Proposed Updated Final Safety Analysis Report Tables and Figures
(Mark-Ups; for Information Only)
(164 pages follow)

FINAL PLANT LAYOUT, PLAN C ABOVE
ELEVS. 620'-6", 623'-6" AND
624'-6", PLANT COMPLEX
FIGURE 1.2-5
(DWG. E-013-0005-00000)

Figure 2.4-6

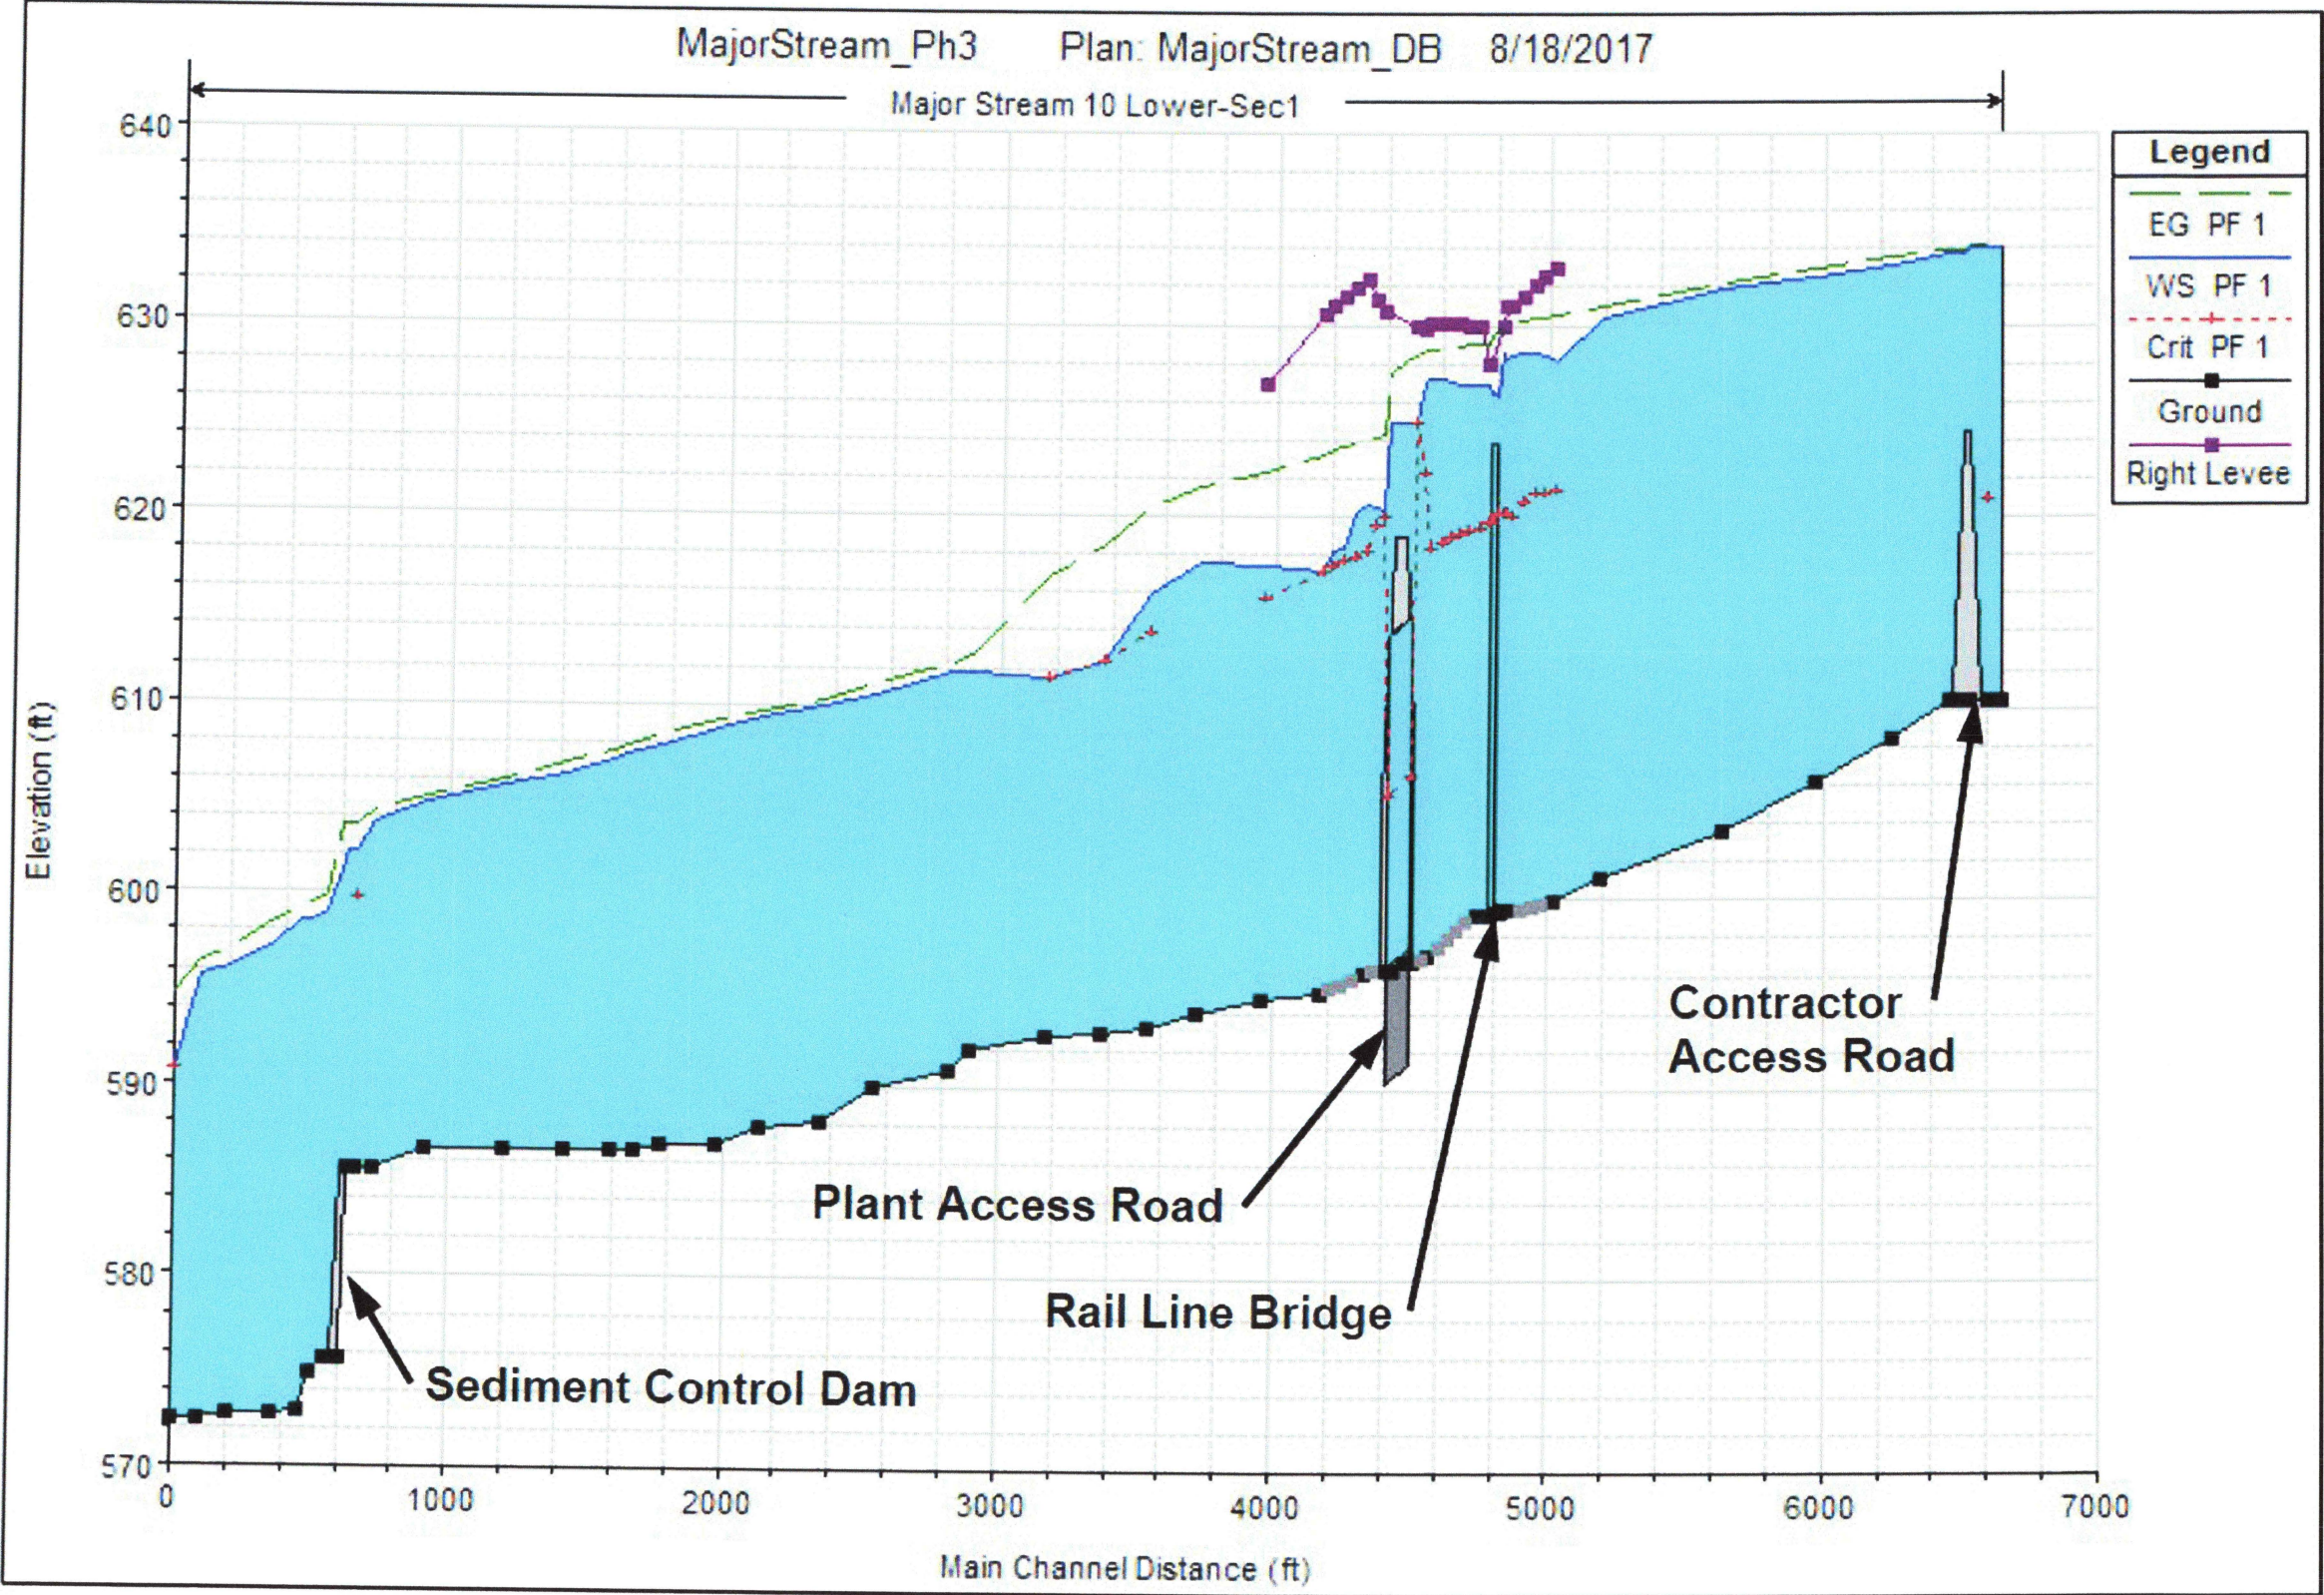
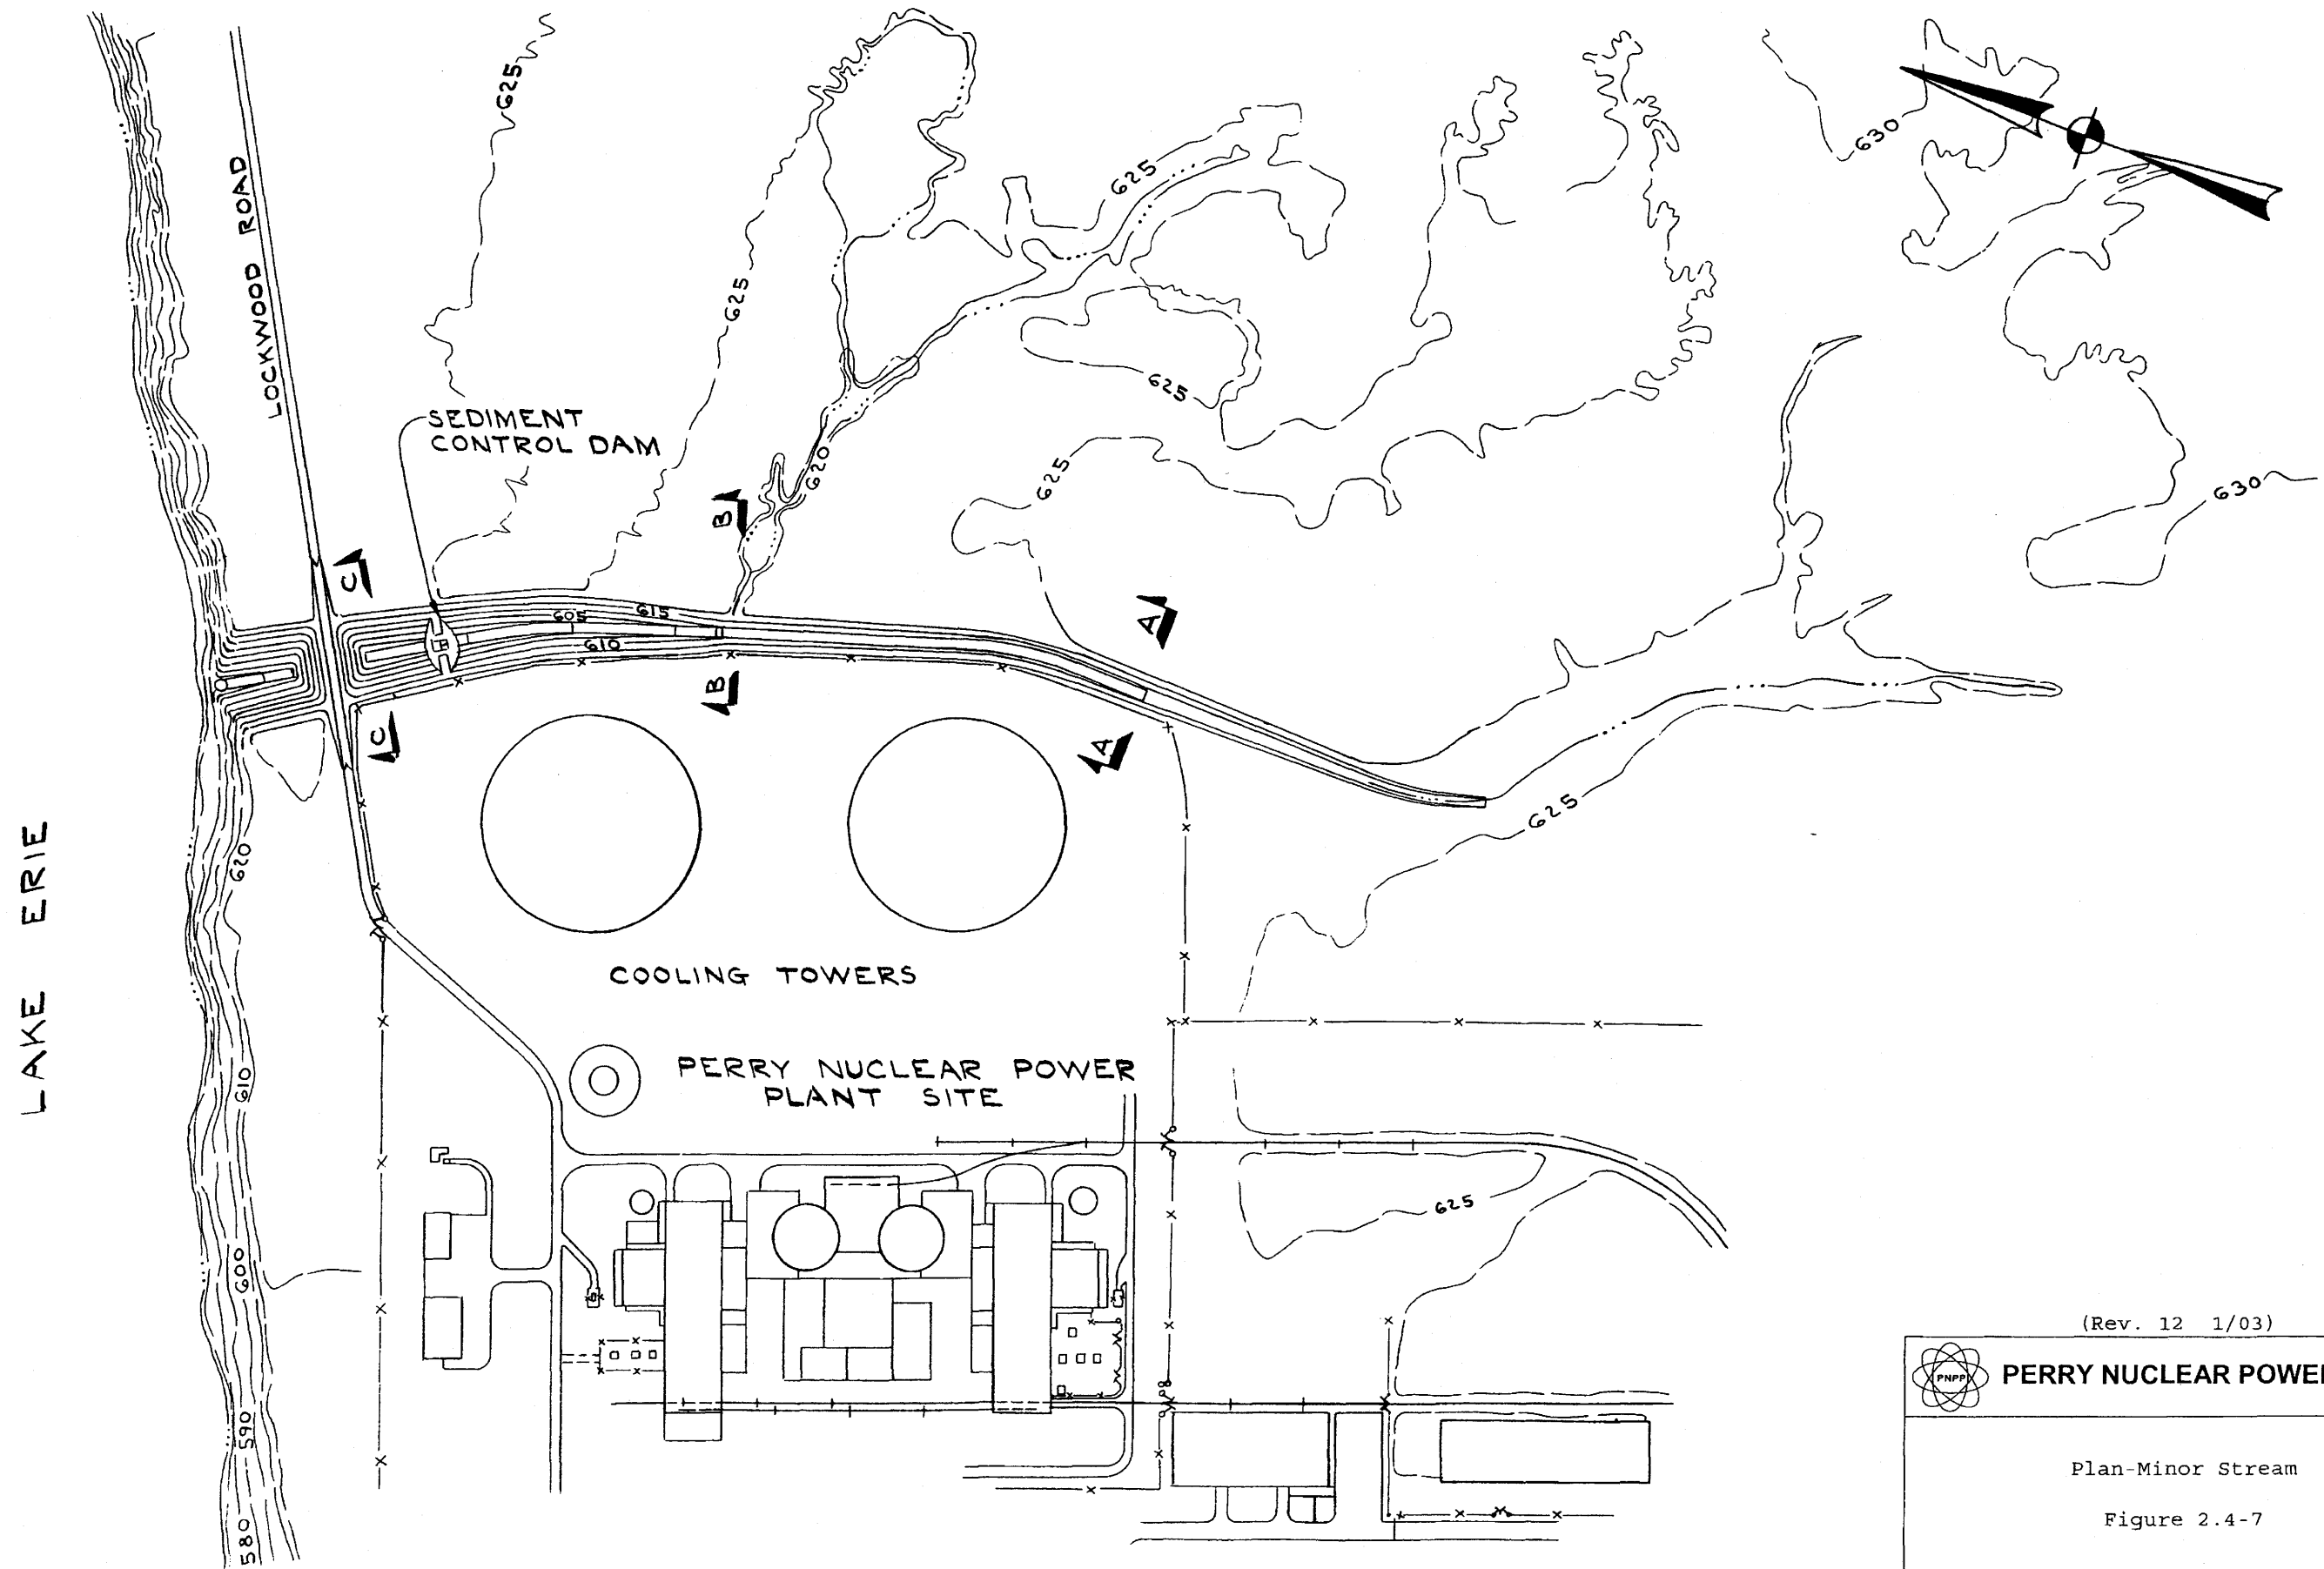
NOTE (NOT FOR
INCORPORATION)
Figure 2.4-6 Revised in
its entirety.

- ADD PER THIS CN
- NOTES:
1. Elevations shown in this Figure are provided in North American Vertical Datum 1988 (NAVD88)
 2. For comparison to plant building elevations, convert NAVD88 to PLD
 3. NAVD88 + 0.93 ft = Perry Local Datum (PLD)
 4. Source: PNPP Calculation 50:72.000
